Generalized Future Land Use Map Comments Summary 6/20/18

Summary of comments discussed at 6/7 and 6/11 PC meetings. Areas for additional discussion are highlighted in orange. Areas where GFLU has been changed based on PC direction are highlighted in grey.

#40-#52: Comments from Schenk-Atwood-Starkweather-Yahara Neighborhood Association (see Legistar #51391, attachment #10; map at end of this file shows specific comment locations)

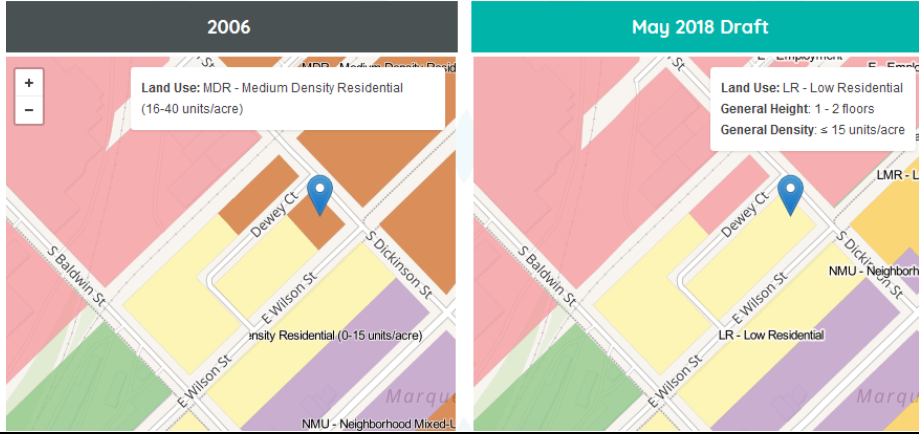
40	SASY #1	Change area #1 from CMU to NMU (see map at the end of this document for detailed SASY comment locations).	The SASY rationale mentions that redevelopment in this area "happened at a scale confined by the 2006 definition of the CMU category which limited height and density to an intense but workable level." However, the 2006 CMU definition did not have a height limit, and while the 2006 definition did specify residential densities of up to 60 DU/acre, in reality projects were approved in CMU areas throughout the city (including in this area) at densities higher than 60 DU/acre. Given that land in this area has been available under these parameters since the 2006 Plan was adopted, staff does not feel that the 2018 CMU parameters, which specify a general density range that matches CMU projects that have been approved since 2006, and unlike the 2006 Plan, specifies a height limit, will impact land values or drive redevelopment any more than has already occurred. Staff does not anticipate that a change to NMU would achieve the objectives desired by SASY, namely preservation of older buildings. Designation of landmarks and creation of historic districts is the primary method for historic preservation. Regardless of the land use designation for a given parcel or area, the GFLU map, by itself, is neutral to preservation concerns because it does not address the age, history, or existing architectural character of structures or areas. Using the GFLU map as a vehicle for preservation with no additional historic district(s), landmark(s), or Neighborhood Conservation Overlay District(s) will not address preservation concerns. Similarly, a change to NMU is unlikely to impact the retention of the limited amount of affordable housing present in the area. Staff feels that this area remains appropriate for a CMU designation, with the language in place in the Plan that specifies an appropriate transition to adjoining lower-intensity uses be integrated with any redevelopment. Regarding Trinity Lutheran Church: civic/institutional buildings and uses are allowable	Maintain CMU	Y (chg. to NMU)

42	SASY #3	Maintain NMU	SASY and staff concur on the GFLU designation.	Maintain NMU	N
43	SASY #4	Change Main Street fronting lots to LR, maintain LMR for East Washington Avenue fronting lots.	Summarizing the breakdown of lots by DU for these two sub-areas (Washington-facing lots and Main-facing lots): Main has 27 single-family, 18 two-family, 5 three/four DU, and 1 five DU. East Washington has 17 single-family, 20 two-family, and 9 three/four DU. Except for the 5 DU parcel, the entire area is zoned TR-V1, which allows up four DUs per parcel. For reference, the net density of this area is 16.6 DU/acre. Staff feels that the makeup both areas is similar, and should be mapped as the same land use (LMR) to reflect current conditions.	Maintain LMR	Y (chg. Main St. fronting lots to LR)
44	SASY #5	Change from LMR to LR.	This area is made up of 4 six DU parcels, 1 four DU parcel, 4 two-family parcels, and 6 single-family parcels. For reference, the net density of all residential parcels in this area is 26.3 DU/acre. Current zoning reflects this mixture, with areas zoned TR-V1 and TR-V2, both of which allow multifamily DUs. This area is correctly classified as LMR.	Maintain LMR	N

45	SASY #6	Change from LR to LMR.	This area is made up of 1 four DU parcel, 3 three DU parcels, 4 two-family parcels, and 9 one-family parcels. Existing development is slightly more in the LR category. Changing from LR to LMR may or may not result in spurring the redevelopment noted in the SASY memo, but could be considered.	Consider change to LMR.	Y (chg. to LMR)

46	SASY #7	Change from MR to SI.	The triangular MR area to the east of Waubesa Street is owned by the Goodman Community Center. It is of sufficient size (~2.75 acres) that it should be shown as a stand-alone SI use, and should have been reclassified as part of the initial GFLU map review. Most of the MR portion west of Waubesa Street is owned by Waubesa Warehouse LLC. It should not be classified as SI; if Goodman or another institutional user were to acquire the property in the future, a residential designation would still allow for a civic/institutional building on the parcel. The Madison Brass Works building, across the Capital City Trail to the south (denoted with a * on the map), was purchased by the Goodman Community Center in December of 2015, and could be reclassified from I to SI as part of the Goodman complex.	Change Goodman from MR to SI. Change Madison Brass Works building from I to SI. Consider changing remaining MR area (~1 acre) to the west of Waubesa Street to LMR.	Y (chg. Goodman and Brass Works to SI, change remaining MR area to LMR)

47	SASY #8	Change from CMU to NMU.	This area was classified as CMU in 2006. Given the general nature of the GFLU map, staff has not tended to change such small areas (in this case, three parcels totaling 0.37 acres) to a different land use than any surrounding land use designation to avoid having the Generalized Future Land Use map begin to appear more like a zoning map. For example, there are many small areas within the LR designation that are more appropriate to the LMR designation, but remain LR to avoid creating small islands of a different category. With the language in the Plan covering appropriate transitions to adjoining land uses, staff feels that there are adequate protections in place to keep a future building from being developed at a scale that is inappropriate to the location. However, the Commission may wish to discuss a change to this area in the context of Area #9 below, perhaps maintaining consistency with whatever land use is decided upon for #9.	Discuss whether the land use for this area should be consistent with the FLU decided upon under #9 below.	Y (chg. to NMU)

48	SASY #9	Change from CMU to NMU.	Most of this area is currently owned by the City of Madison Economic Development Department. The Gorman Company has proposed the "Union Corners Grandfamily Apartments" project, which is currently making its way through the approval process. The proposed development fits within the CMU category, and would, of course, be unlikely to be redeveloped over the next 50 years if/when it is constructed. If there is a desire to reclassify the area, the "Grandfamily" parcel's proposed residential use may be more appropriately classified as MR than NMU. The parcel is of sufficient size (3.2 acres) that a FLU category that is different from its surroundings could be considered. There are two single-family residential parcels fronting Farwell Street that are classified as CMU. These should be changed to LR.	Discuss whether the "Grandfamily" parcel should be categorized, and, if so, whether it should be NMU or MR. Change the two Farwell Street parcels to LR.	Y (chg. to MR; chg. Farwell parcels to LR)

49	SASY #10	Change from NMU to LR or LMR.	The Darbo-Worthington-Starkweather Neighborhood Plan, which was just adopted by the City Council on September 19, 2017, designates this area as NMU. Given the extensive and very recent planning process, staff feels it would be inappropriate to change the designation for this area in the Comprehensive Plan.	Maintain NMU.	N
50	SASY #11	Maintain CMU, with a note to scale development down to meet the LR to the east and south.	The SASY request advocates for maintaining the CMU designation, with plan notes for scaling down to meet the LR areas to the east and south. The Plan text does specify that appropriate transitions from higher-intensity redevelopment to lower-intensity neighborhoods are needed (see Land Use and Transportation Strategy #5).	Maintain CMU.	N
51	SASY #12	Change from P to something more appropriate for the development occurring there.	The former Garver Feed Mill building is being restored and repurposed for use as a food production facility with new "microlodges" to the north of the building. While substantial greenspace will remain in this area, staff agrees that a portion of area #12 should be reclassified to employment better fit the Garver uses (the current #12 boundary was drawn to closely match the SASY boundary, but staff recommends narrowly tailoring the change to only encompass the Garver building and microlodge area). The Parks Department has been consulted on this potential edit and has no objection.	Change the Garver building and microlodge area to E (Employment).	Y (chg. to E)

52	SASY #13	Change from E to CMU.	The conditional use for redevelopment of the former Kessenich's property 131 S. Fair Oaks avenue to a mixed-use project with 11,000 square feet of commercial space and 161 apartments was approved by the Plan Commission in November of 2017, which is well after the spring 2017 staff GFLU revisions and the Plan Commission's summer 2017 discussion of GFLU map edits. The approval of this project, combined with the approval of a conditional use at 134 S. Fair Oaks in December 2016 to allow construction of 80 apartments and 2,500 square feet of commercial space (a project that was in doubt when the Council denied TIF assistance in February 2017, then approved TIF assistance in December 2017), means that this area is now most appropriately classified as CMU, as discussed by SASY.	Change to CMU.	Y (chg. to CMU)
53	B. Cantrell	Change the area on the west side of Merry Street to LMR and leave the east side LR.	The Plan Commission previously recommended that both sides of Merry Street be designated as LR. There is a large residential building on the west side of the street which would better fit into LMR and many of the residences along that side of the street are two family homes.	Revert west side of Merry Street back to LMR as shown on a previous draft of FLU map.	Y?

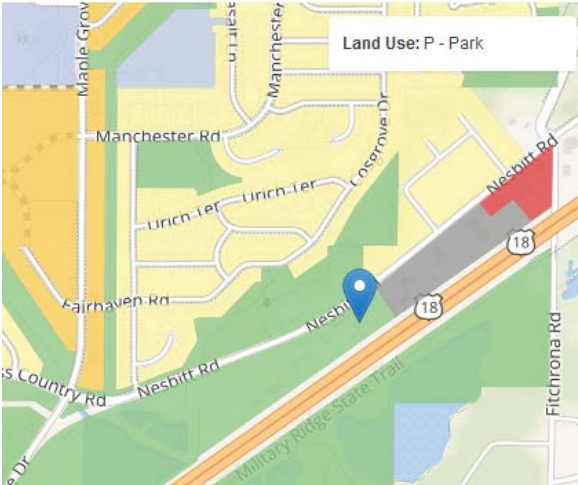
5	4/19 Owen Message	Too-tall buildings are allowed in the SASY neighborhood.	Much of the SASY neighborhood remains the same FLU as the 2006 map. A specific location is not mentioned – it is unclear which part of the neighborhood the person is discussing.	SASY FLU was discussed at the 6/7/18 PC meeting and will be edited per PC direction.	N

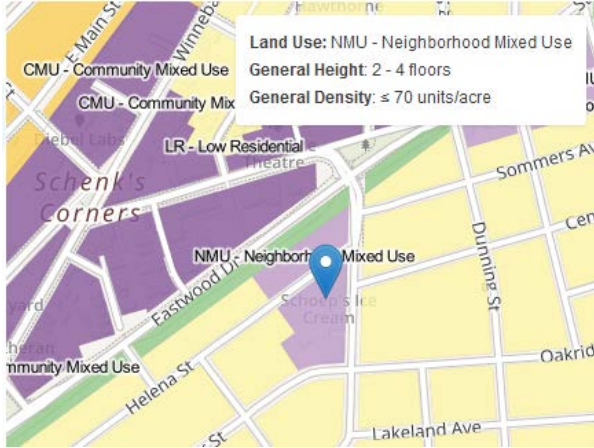
6	4/19 Becker Message	Density – 6 story buildings - proposed for the “Atwood area” is completely out of character.	No specific area is mentioned. See SASY FLU analysis.	See #5 above.	N
7	6/4 Barrett Email	SASY’s GFLU comments do not go far enough in opposing “the wholesale destruction of our classic old neighborhoods.”	--	See #5 above.	N
8	5/29 Krauskopf Message	Why was the Carey Ct. area changed from LR to LMR?	LMR is based on the current unit mix for the area (mix of single-family, duplex, and 3+ DUs). The message does not make a request to change the GFLU designation. See the discussion below for a location map and further analysis.	Maintain LMR.	N
9	5/29 sjkrausk Message (#1)	Restrict buildings on the 2000 block of East Washington (on the N side) to two stories.	Staff interprets this as a request to change the area from LMR to LR. This area, along with the Options in Community Living apartments to the southwest and the E. Washington Ave. frontage to the northeast, were LDR in 2006. Staff reclassified the area with the addition of LMR as a category with this Plan update. The block bounded by Carey Ct., 2nd St., E. Washington Ave., and 3rd St., is made up of small-lot single family (generally 2,900-3,700 square foot lots), with three duplexes and one three-unit. This development is less intense than other LMR-designated areas to the southwest, southeast, and northeast, but the block is different than the exclusively single-family block to the northwest. Discussion of this area at the 6/11 PC meeting led to the Commission instructing staff to review the area to determine whether any changes to the map would be appropriate, given the location of the planned public market and the prominence of the First St. / E. Washington Ave. intersection.	Maintain LMR for the originally commented upon area (marked with a pin). Change area A at left to CMU (the area is already zoned for mixed-use development); change areas B and C at left to LMR.	Y?

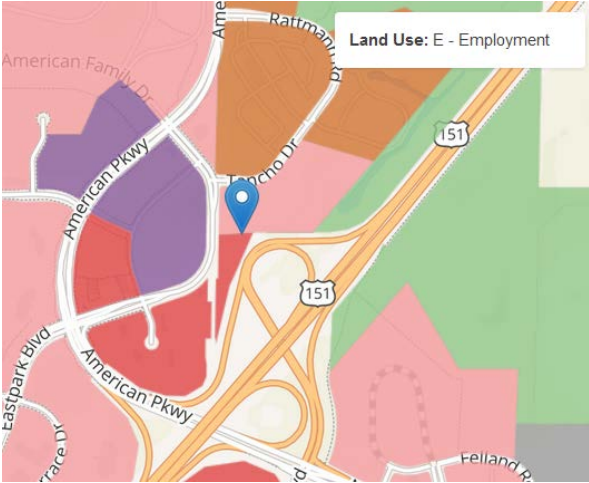
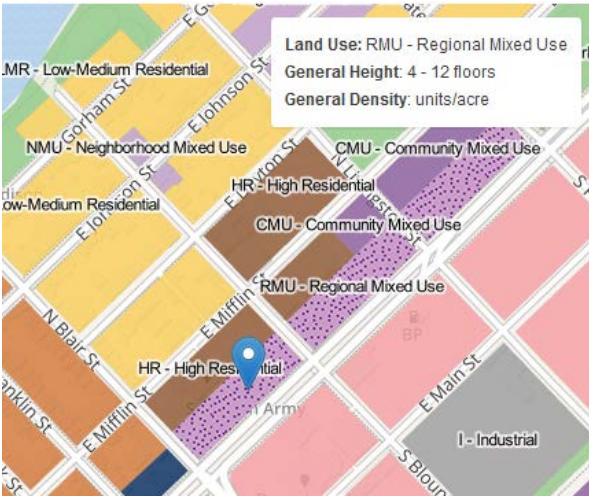
10	5/25 Dwyer & Lathrop Email	Change Les Chateaux Apartments from MR to LMR to better match the Hoyt Park Neighborhood Plan designation of 16-25 DU/acre and 2-3 stories. 	The Comprehensive Plan focuses on building form over density, and the building form and site layout of Les Chateaux Apartments, which has 128 units in 7 buildings on 8.5 acres, is more appropriate to the MR category. An LMR designation for this area, which is not along an arterial road, would be an indication that the type of building that currently exists is not appropriate for the area. This request is similar to the Marquette Neighborhood Association request to change the Fauerbach Condominiums from MR to LMR – while the parcel may meet the density range for LMR, the building form is not appropriate for LMR. MR is the best category for both existing and potential future redevelopment, which would still need to operate under the Neighborhood Plan.	Maintain MR designation.	N

11	5/25 Dwyer & Lathrop Email	Change parcels along Harvey St. between Schmidt Pl. and Hill St. from MR to LMR to better match the Hoyt Plan designation of 2-3 floors and 16-25 DU/ac. 	The area described at left is not specified for 16-25 DU/ac in the Hoyt Plan. In fact, the plan states that the area has “opportunity for higher density uses through lot assembly and redevelopment.” The area in question (area G on page 36 of the Hoyt plan) is specified to transition from taller buildings along University Avenue to a 2-3 story maximum along Harvey Street. 2-3 stories is within the MR range. The Comp Plan residential categories not only address height, but also building form. Staff feels that the building forms within the MR category are more appropriate for this area than the LMR category. The recommendations in the Neighborhood Plan as far as a 3 story height limit will remain.	Maintain current MR designation.	N

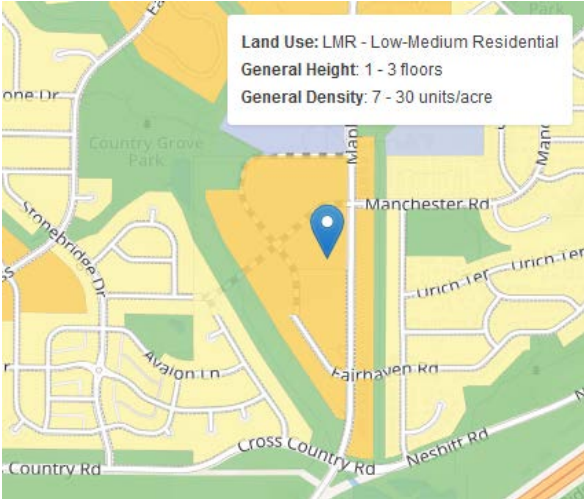
14	5/11 O'Donnell Messages	Retain MR for land between W. Washington and W. Main south of Proudfit. The block bounded by W. Main, Proudfit, Brittingham, and S. Brittingham should remain LR.	See #17 below for MR/HR discussion. The Commission instructed staff to change the block bounded by W. Main, Proudfit, Brittingham, and S. Brittingham to LMR at their 6/7/18 meeting.	Comment addressed at 6/7/18 PC meeting.	Y (see GFLU map)
15	5/19 Leigh Email	Leave the entire block from W. Main, Proudfit, W. Brittingham and S. Brittingham as LR.	The Commission instructed staff to change the block bounded by W. Main, Proudfit, Brittingham, and S. Brittingham to LMR at their 6/7/18 meeting.	Comment addressed at 6/7/18 PC meeting.	Y (see GFLU map)
16	6/5 Pelski Email	“the neighborhood and its residents, after several meetings and discussions, strongly oppose adjusting zoning/height restrictions from the 2006 plan to High Density for the Properties between West Washington, Proudfit, and West Main St; these properties are known as Parkview Apartments, Journey and the vacant property on the corner. Additionally, the Monona Bay neighborhood and its residents oppose moving from low-density for the block surrounded by West Main Street (700 block), South Brittingham, West Brittingham and Proudfit streets. Finally, the properties on the West Shore of Monona Bay will be addressed in our plan, and we ask that we maintain the 2006 plans regarding height and density.”	See discussion below regarding HR/MR for the Parkview Apartments. The Commission instructed staff to change the block bounded by W. Main, Proudfit, Brittingham, and S. Brittingham to LMR at their 6/7/18 meeting.	See #17 below.	Y (see GFLU map)

17	5/10 Pelski Email	Keep the Brittingham area with the same FLU as the 2006 Plan. Include the area in the City’s renter-occupied to owner-occupied grant programs that had been developed for Greenbush and Tenny. 	The Commission instructed staff to change the block bounded by W. Main, Proudfit, Brittingham, and S. Brittingham to LMR at their 6/7/18 meeting. As discussed at the 6/7/18 PC meeting, the Parkview Apartments area will be split between HR along W. Washington and MR along W. Main St. HR remains appropriate along W. Washington due to the area’s excellent transit access, proximity to downtown and employment, adjacency to a park and community gardens, excellent access to the shared-use path network, and location close to shops and a grocery store. Strategy 6-c in Neighborhoods and Housing addresses the second comment. Inclusion in such a program would require a tax increment district be created for (or adjacent to) the area.	Implement GFLU edits as discussed at left.	Y (see GFLU map)

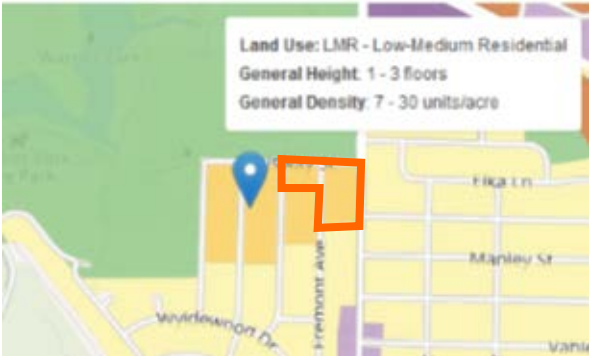
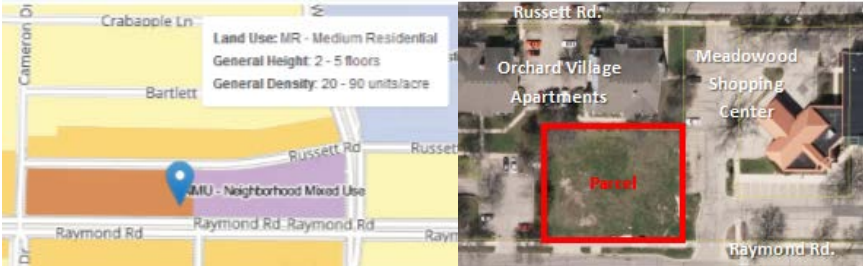
23	6/4 Town of Verona Letter	Two main points are covered: - General expression of interest in pursuing an intergovernmental agreement that covers services, boundaries, and extraterritorial jurisdiction. - Would like to see uses along Nesbitt Rd. remain in the town – they are important to the Town’s tax base. 	Effective Government action #4-c advocates for entering into intergovernmental plans and agreements when it is beneficial to do so. The City could explore such an agreement with the Town of Verona under this action, and such an agreement could cover a long-term boundary between the City and Town.	--	N
24	6/7 Lehnertz Message	Change the southern half of the northern side of the 800 Williamson block from CMU to NMU. 	The Plan Commission reviewed Marquette Neighborhood Association (MNA) suggestions for GFLU map edits in detail at their March 2018 work session. This edit was not requested by MNA at that time. The Williamson Street BUILD Plan recommends buildings up to three stories along the north side of Williamson Street, and up to four stories on the side of the block facing the Capital City Trail. This is distinct from the CMU area across Livingston to the west, which is recommended for up to five stories in the BUILD plan. Staff believes that either CMU or NMU could be appropriate for this block.	Consider changing to NMU.	Y (chg. to NMU)
